ALERT SERVICE BULLETIN

Exchange of exhaust valves on ROTAX® Engine Types 915 i A, 915 i B (Series) and 914 (Series)

ATA System: 72-00-00 Engine

Fig. 1
Exchange of exhaust valves

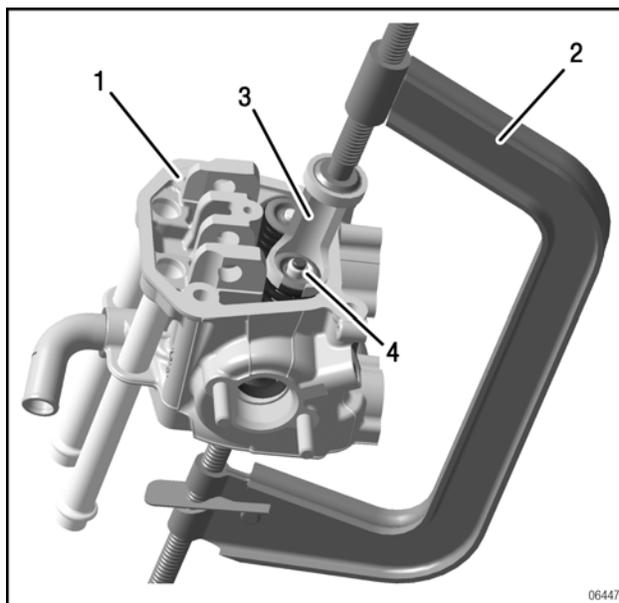
3.3) Exchange exhaust valves 32 mm (1.26 in.) on cylinder heads

Step	Procedure
1	Remove the affected exhaust valves according to relevant Maintenance Manual Heavy (MMH).
2	Install new exhaust valves according to relevant Maintenance Manual Heavy (MMH).

Fig. 2
Identification of exhaust valves

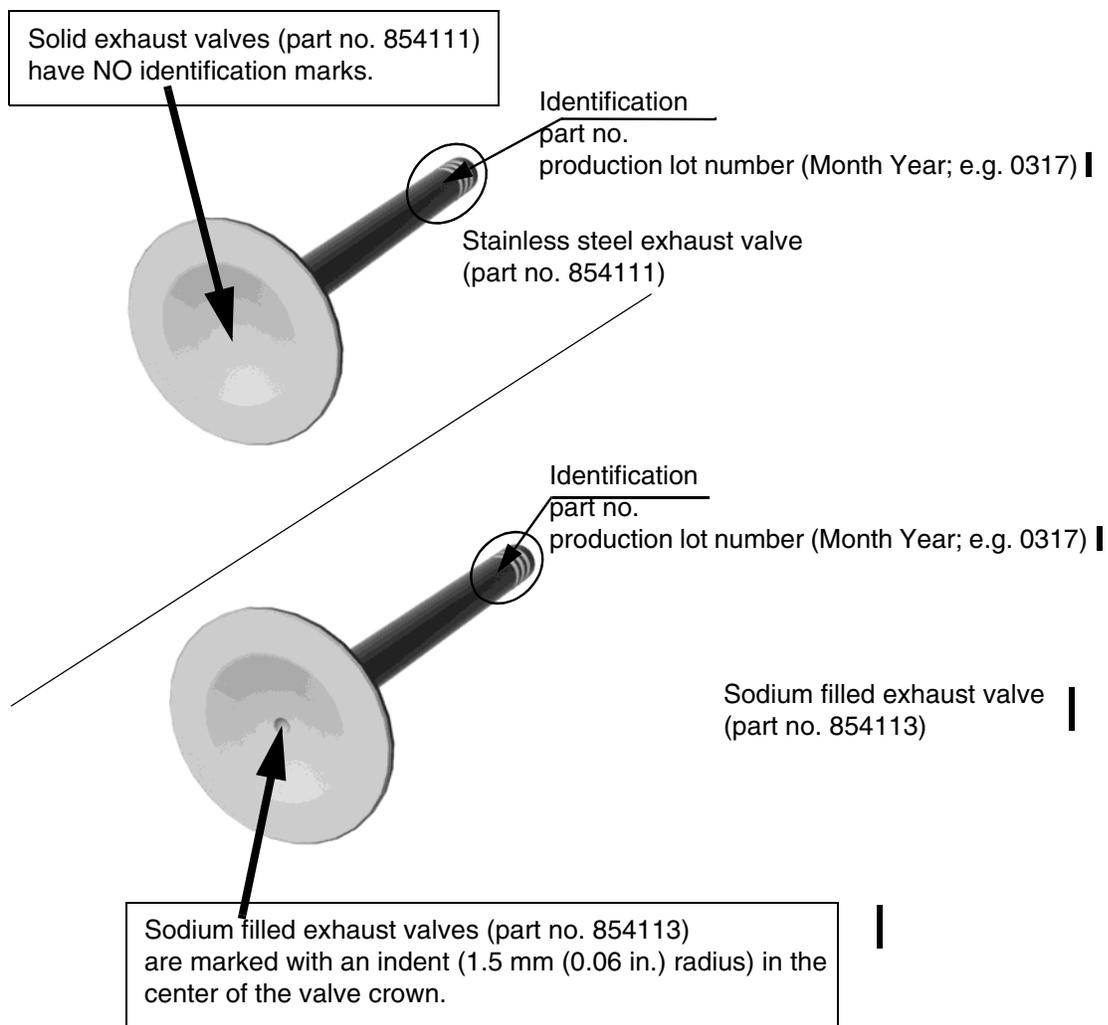
The engines below have been fitted by the manufacturer with an exhaust valve 32 mm (1.26 in.) part no. 854113 with a variety of production lots from which the production lot numbers 0317 and 0517 (see Fig. 2) are affected.

All engines are affected, which have been equipped with an exhaust valve 32 mm (1.26 in.) with part no. 854113 with a production lot number 0317 and 0517 during engine repair, maintenance or general overhaul (see Fig. 2).

Due to deviations in the manufacturing process of the exhaust valve 32 mm (1.26 in.) with part no. 854113 (for production lots affected see section 1.1) an exhaust valve cracking / fracture may occur. In consequence this may result in a malfunction of the valve train and a subsequent engine stoppage.

Further all exhaust valve 32 mm (1.26 in.) with part no. 854113 with a production lot number 0317 and 0517 sold as a spare part are also affected (see section 1.13).

- All affected parts cannot further be used and must be marked unserviceable. These parts must be returned FCA (Free CArrier) to ROTAX[®] Authorized Distributors or their independent Service Centers
- Further sale, use or shipment of all affected exhaust valves part no. 854113 (see section 1.1) in stores (e.g. replacement parts) is not allowed and must be returned FCA to ROTAX[®] Authorized Distributors or their independent Service Centers
